**SITE PLAN REVIEW COMMITTEE
MEETING AGENDA**

| Item 2. | 1700 & 1810 N. Moore Street (SP #94, AREP Rosslyn City Center)

ITEM 2
1700 & 1810 N. Moore Street
(SP #94, AREP Rosslyn City Center)
(RPC#'s 16-037-001; -007; -008; -16-038-004)
Nancy Iacomini, SPRC Chair

BACKGROUND: The applicant proposes internal refurbishment and external reconfiguration of an existing retail mall located above the Rosslyn Metro Station, including the addition of approximately 17,000 sq. ft. of new gross floor area (GFA). The subject site is located at the Rosslyn Metro Station at 1700 and 1810 N. Moore Street. Plans and policies applicable to the site include *The Rosslyn Sector Plan (2015)*.

Figure 3-4 (from page 144 of Rosslyn Sector Plan)

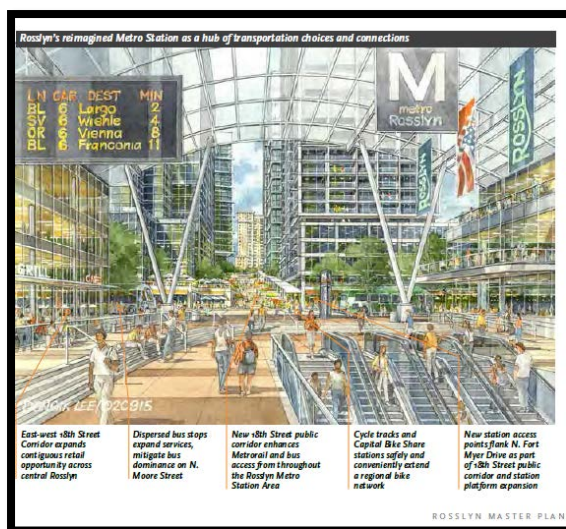
18th Street – Rosslyn’s New Urban Spine (p. 142-5): In the plan’s more detailed recommendations involving 18th Street, the sector plan reiterates much of the same ideas presented on page 99 of the plan, particularly as it relates to the Metro Station Plaza as a space for “Public Interaction Around Transit”. Additionally, it provides a conceptual plan for the entirety of the corridor extension, showing the transformed, open-air Metro Station Plaza as a central focal point of Rosslyn along this new corridor.
